In the figures:

FIG. 26

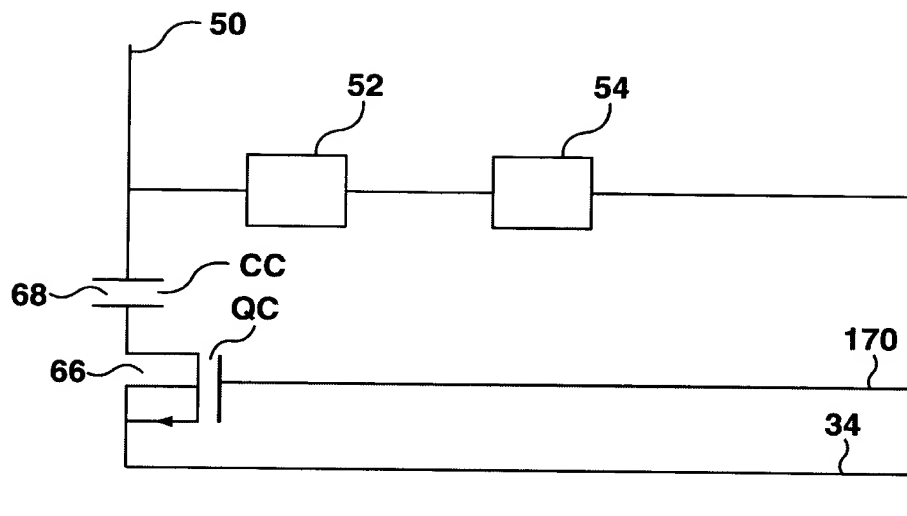
Please replace original Figure 26 with the enclosed Figure 26 which has been amended to show the correct labeling of the synchronization element **66** and the coupler **68**.
